# 5 SUB-000296-2017

### **MERIFIELD SUBDIVISON**

# **DETAIL SITE PLAN**

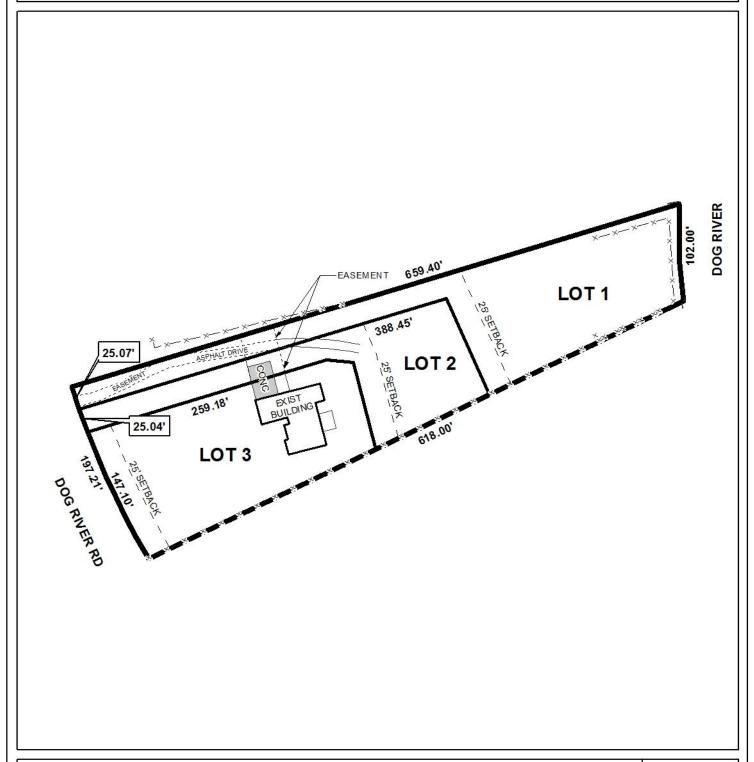
The proposed lots front Dog River Road, a minor street requiring a 60' right-of-way width. The preliminary plat does not provide the right-of-way width to Dog River Road. If approved, the right-of-way width to Dog River Road should be illustrated on the Final Plat, with dedication to provide 30' to the center line, if appropriate.

It should be noted that the proposed Lots 1 and 2 are flag shaped lots however; the Planning Commission approved a similar configuration of the site in 2001 as Hollingers Island Subdivision, Dog River Division, Resubdivision of Lot 10, Block 1. There is currently a single-family dwelling on the proposed Lot 3. The preliminary plat illustrates an easement on the proposed lots, but does not label the type of easements. There appears to be a concrete slab within one of the easement(s), as illustrated on the preliminary plat. If approved, a note should be placed on the Final Plat stating that no structures shall be erected in any easement, and the type of easement should be labeled.

In accordance with Section V.D.2. of the Subdivision Regulations, the proposed lots exceed the 15,000 square foot minimum lot size requirement for lots served by public water and septic tanks. The lot size information is depicted in square feet and acres on the preliminary plat and, if approved, should be retained on the Final Plat, adjusted for dedication if necessary.

The preliminary plat illustrates a 25' minimum building setback line for Lot 3 along Dog River Road. A 25' minimum building setback line is also depicted for proposed Lots 1 and 2 where the lots are at least 60' wide. If approved, the minimum building setback lines should be retained on the Final plat, adjusted for dedication if necessary.

- 1) Retention of the 25' minimum building setback line for Lot 3 along Dog River Road and where Lots 1 and 2 are at least 60' wide;
- 2) Provision of the right of way width to Dog River Road and dedication to provide 30' to the centerline if necessary;

- 3) Retention of lot size information in both square feet and acres;
- 4) Placement of a note on the Final Plat stating no structure shall be erected in any easement:
